# UNITED STATES PATENT AND TRADEMARK OFFICE

APPLICATION NO.	FILING DATE	FIRST NAMED INVENTOR	ATTORNEY DOCKET NO.	CONFIRMATION NO.
10/823,634	04/14/2004	Shinya Inagaki	826.1633D	4656

**Office Action Summary**

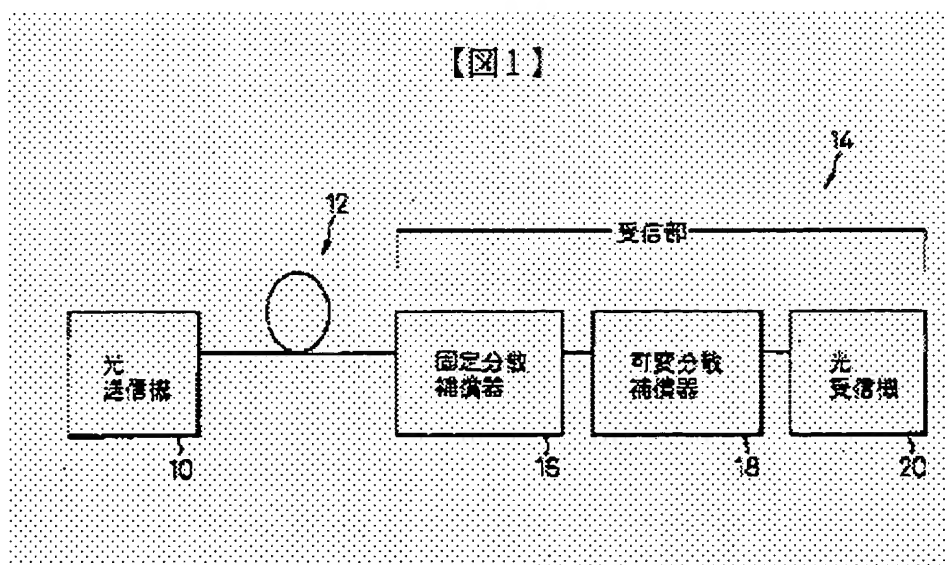
3. Claims 92, 96 and 98 are rejected under 35 U.S.C. 102(a) as being anticipated by Ishikawa (JP 11-088260).

With respect to claim 92, Ishikawa (Fig. 1) discloses an apparatus comprising a first compensator (16) compensating wavelength dispersion, the first compensator having a constant wavelength dispersion characteristic over a plurality of wavelengths (see the abstract); and a second compensator (18) compensating wavelength dispersion after wavelength dispersion is compensated by the first compensator (16),

wherein the first and second compensators together compensate for wavelength dispersion dependent on a respective wavelength of a transmission line (see figure 1).

With respect to claim 96, Ishikawa (Fig. 1) discloses an apparatus, wherein the respective wavelength is the wavelength of a respective signal light included in a wavelength division multiplexed (WDM) light transmitted through the transmission line and including a plurality of signal lights at different wavelength multiplexed together (see figure 1).

With respect to claim 98, Ishikawa (Fig. 1) discloses an apparatus comprising first means (16) compensating wavelength dispersion, the first means having a constant wavelength dispersion characteristic over a plurality of wavelengths (see the abstract); and second means (18) compensating wavelength dispersion after wavelength dispersion is compensated by the first means (16), wherein the first and second means together compensate for wavelength dispersion dependent on a respective wavelength of a transmission line (see figure 1).
